COUNCIL ASSESSMENT REPORT

Panel Reference	PPSSNH-763
MOD Number	MOD2025/0114
LGA	City of Ryde
Parent DA	LDA2018/0506 Demolition of existing buildings, excavation and site preparation work, construction of a 20 storey mixed use building comprising retail uses on the ground floor and 132 residential units over five levels of basement parking, construction of a retail building at the Waterloo Road frontage known as the 'Cyclist Cafe' and associated landscape and public domain works.
Proposed Development	S4.55(2) modification to LDA2018/0506 as amended by MOD2024/0012 for: • Increase to the building height from 67.2m to 75.3m (+8.1m) and 19 storeys to 22 storeys. • Increase to the gross floor area from 11,243.5m² to 14,137m² (+2,893.5m²). • Increase to the floor space ratio from 4.49:1 to 5.66:1. • Increase to residential apartments from 101 to 126. • Revision of the ground floor podium and communal spaces. • Redesign of the retail space. • Reconfiguration of apartment sizes and mix. • Amendments to landscape design and water management. • Amendments to basement levels and layouts including an increase to the provision of parking from 133 spaces to 152 spaces.

Street Address	14 to 16

Figure 6 – Comparison of the original retail/terrace and the amended retail/terrace.

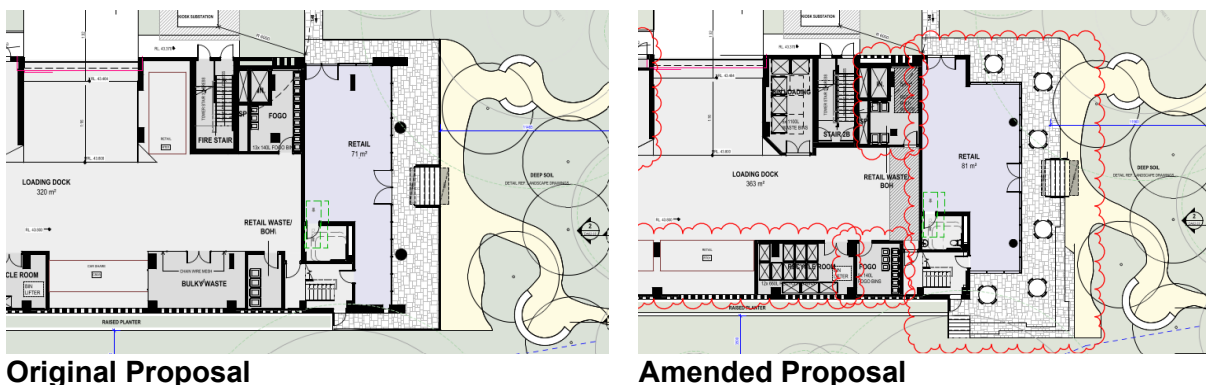
“The retail tenancy floor level has been lowered by 420 mm, enhancing its relationship with the adjacent landscape and bringing it closer to the natural ground plane. As a result of this reduced level change, the bleacher seating previously required to conceal an accessible ramp is no longer necessary.

The amendment improves the relationship of the retail / terrace space to the landscaped area to some extent however the concerns raised by UDRP in relation to its overall relationship with the landscape area remain unresolved.

Figure 7 – Comparison of the original lobby and the amended lobby.

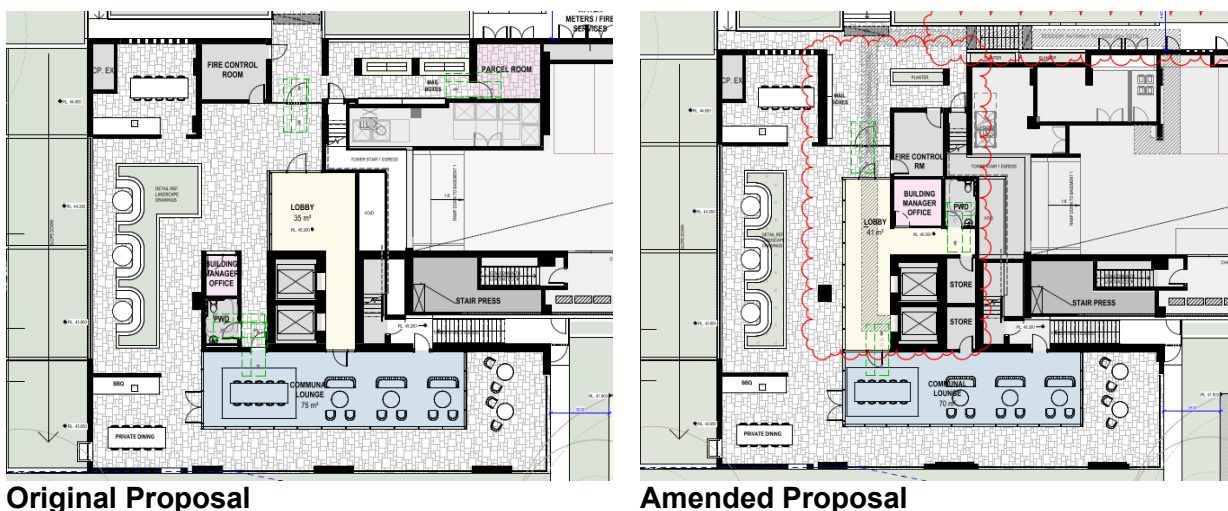
UDRP Issue 2: “At ground level at the primary residential lobby, the MOD introduces a short flight of stairs to the street (with attendant accessible ramp), reduces the extent of glazed lobby space, and removes the implied link through the lobby to the Creek reserve. The elements of private dining have been reconfigured and reduced, the reflection pond omitted, and a new communal lounge is proposed. There no longer appears to be a resident link to the Creek reserve. Overall, I feel that the clarity of the planning, the arrival experience and the quality of communal facilities has diminished. I have no problem with the reduced lobby

The lobby at the ground floor level has been amended to increase the extent of glazed space. and improve the link through the lobby. The direct stair access/egress to Shrimptons Creek Reserve (which was included in MOD2024/0012) has been removed due to site level differences.

This matter is partially resolved.

“Flood modelling required the ground floor lobby to be positioned 500 mm above the 1% AEP flood level. This established a minimum finished floor level of RL 45.130, which is 610 mm higher than the previous approved/modified design. As a result, the lobby entry sequence has been reconfigured to manage this increased level change.

Figure 8 – Comparison of the original communal areas and the amended communal areas.

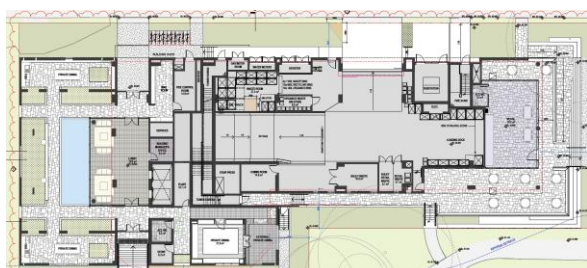
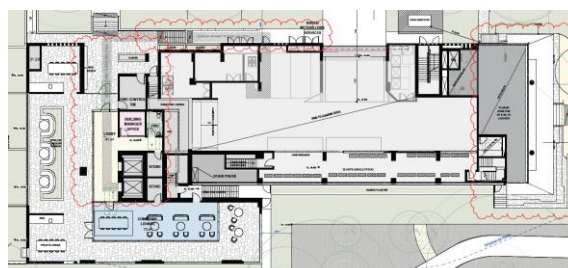
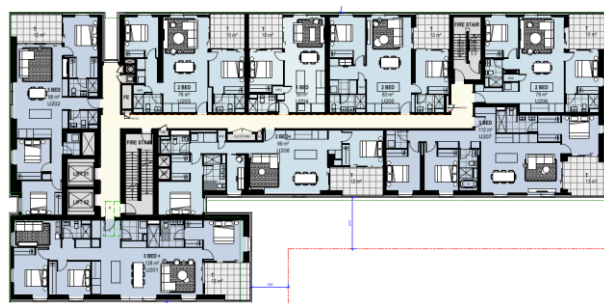
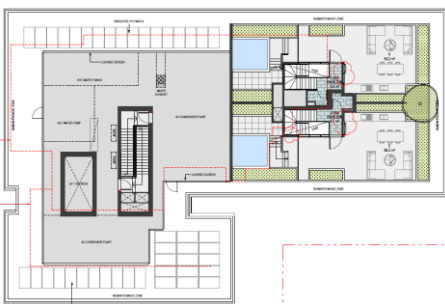
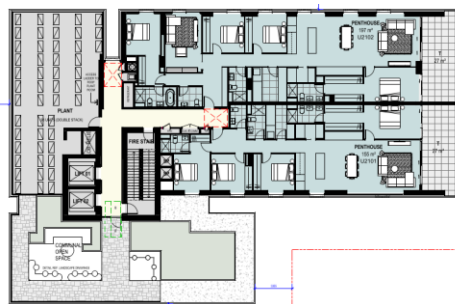
"The reconfigured communal spaces and adjustments to the amenities reflect current market conditions for this product type and the expectations of the intended purchaser demographic. The revised approach focuses on delivering three key communal zones, at Ground Level, Level 3, and Level 21, that together provide a diverse range of high-quality amenity for residents.

Figure 8 below provides a level-by-level comparison of the redistribution of the communal open space.

Figure 10 – Height breach (height blanket).

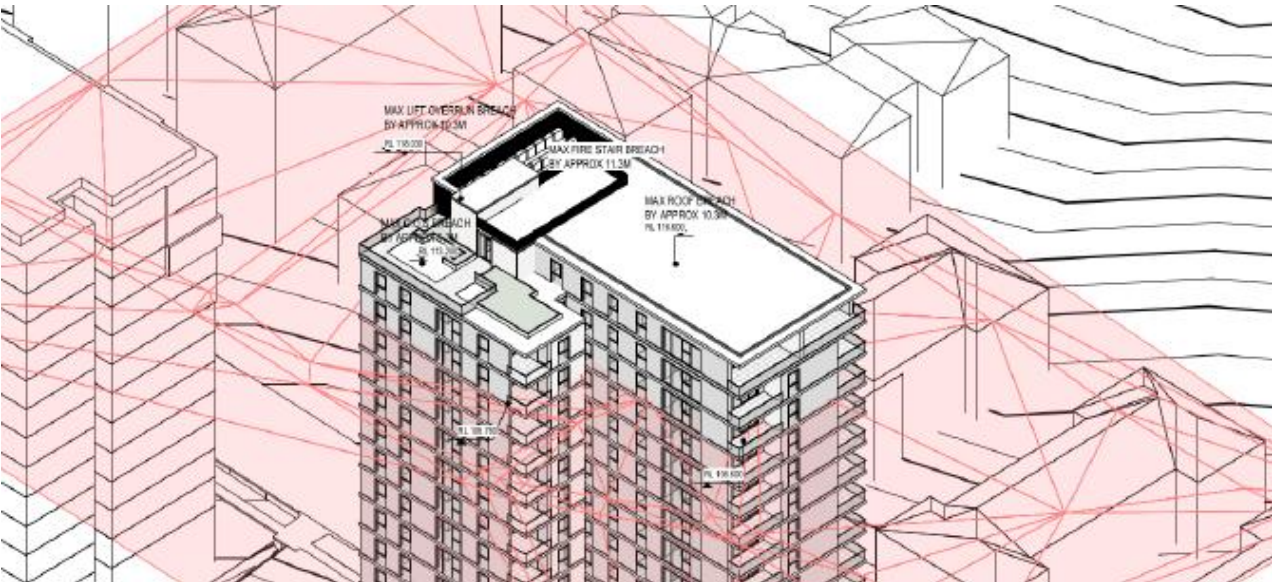
As noted in **Table 10** above, the development increases the building height by 10.3m representing a variation to the permitted building height of 15.8%.

Figure 10 below shows the height breach above the 65m height plane (the pink shading depicts the permitted 65m height plane).

Figure 11 – Height breach (sections).

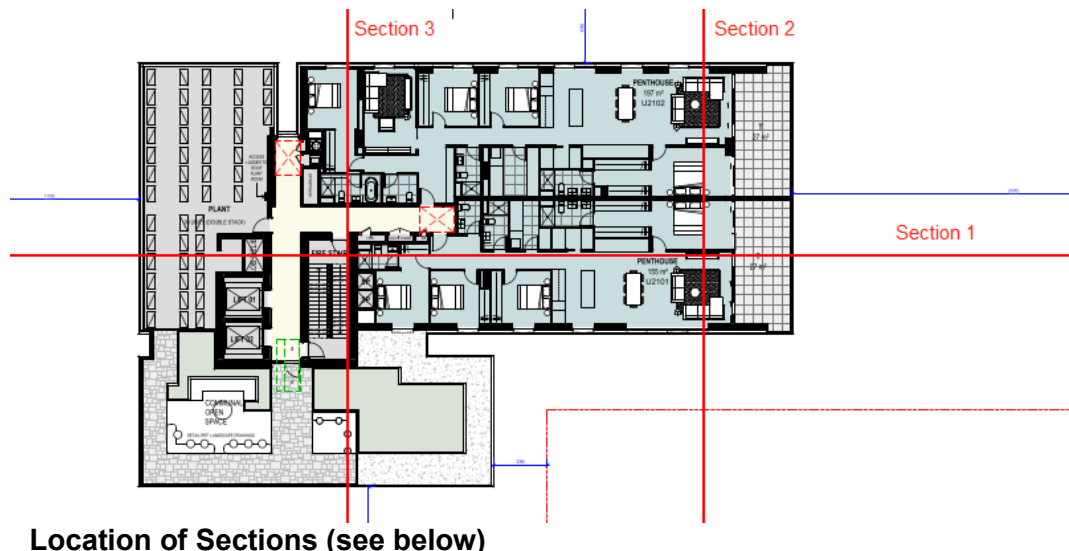
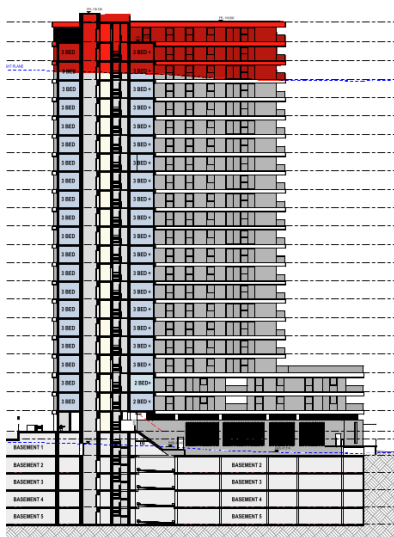
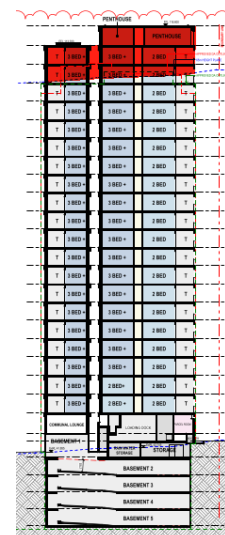
Figure 11 below shows the proposed building height above the 65m height blanket.

Figure 12 – Shadow diagrams (21 June).

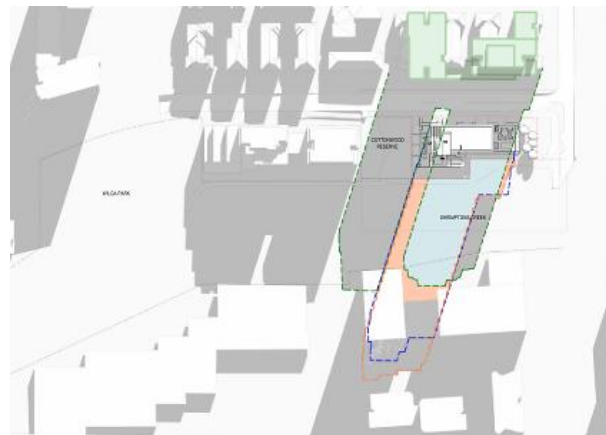
Review of the architectural plans confirms that the proposal would not materially increase overshadowing of adjoining properties, including 82 Waterloo Road, given the building's orientation and the shadowing already approved.
